**S.4.55(1A) MODIFICATION 3, SSD-66777221 – LANCELEY PLACE DATA CENTRE,
MINOR ARCHITECTURAL PLAN MODIFICATION**

This is the **third (3rd)** modification to SSD-66777221 and **seeks minor architectural updates to the switch room and reinstatement of a Lanceley Place crossover.**

2.1.1 Switch room update

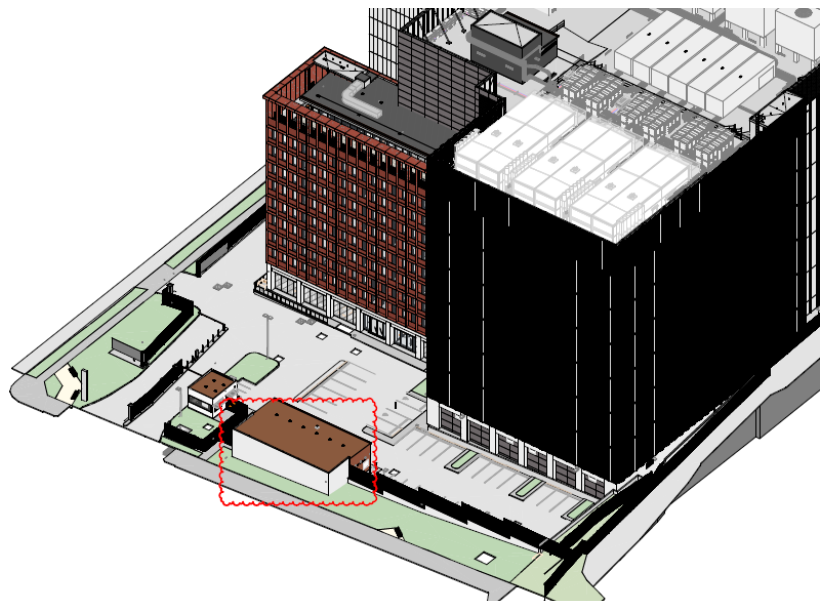
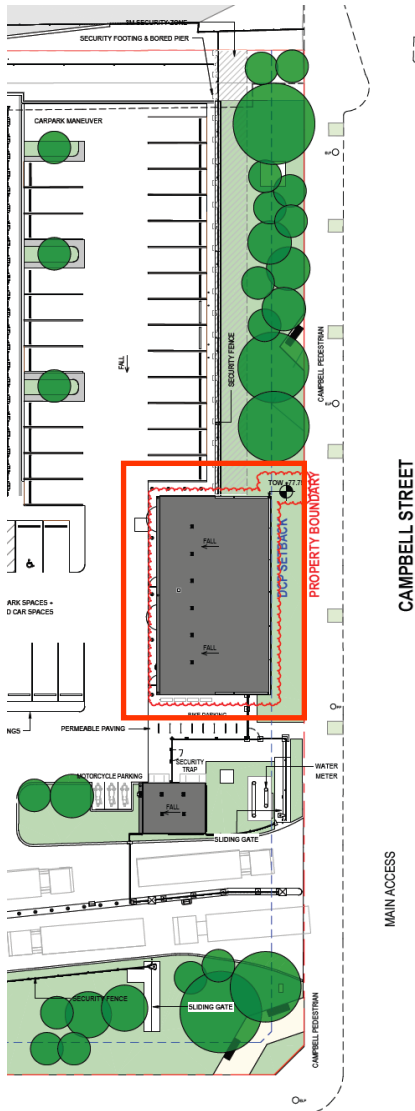
Increase the height of the external switch room located along the site's southern frontage to Campbell Street from 4.045m to 5.250m, an minor increase of 1.205m.

The approved switch room height was based on generic, vendor-neutral air insulated switchgear. GPSA has now selected Eaton gas insulated switchgear (GIS), which is slightly taller than originally assumed. As a result, an extra 1.205m of vertical clearance is needed to allow components to be replaced from the top and rear.

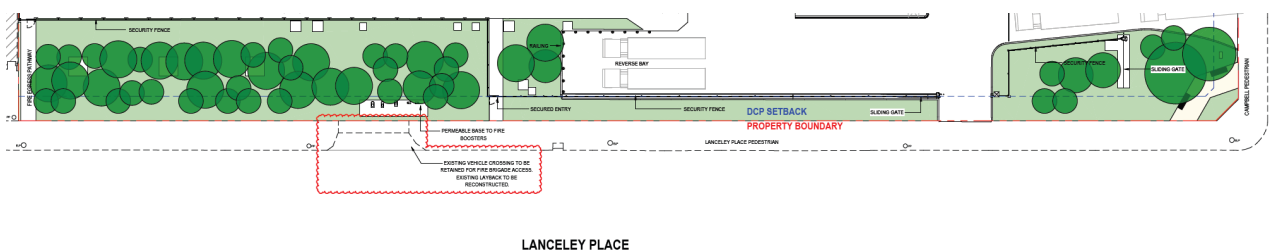
Fire Brigade crossover required along the site's western boundary fronting Lanceley Place, adjacent to the Fire Booster.

It's noted this crossover is existing, however was proposed for removal in previous plans. This MOD seeks to reinstate this crossover for essential booster access.

FRNSW have specific requirements for unobstructed, all-weather access to fire brigade infrastructure, including fire booster assemblies.

Section 8.1.2 of the 'Access for fire brigade vehicles and firefighters' guideline, the designated hardstand area is to be flat and level all weather surface which is clear of any obstructions that could be hazardous during operations (e.g. bollard, railing, fencing, sign, kerb, gutter, fixed structure, parked vehicle, storage, rubbish). Accordingly, and as identified in the approved Fire Safety Study for the Project, FRNSW has requested that the existing crossover adjacent to the booster assembly be retained to ensure safe and efficient maintenance access.
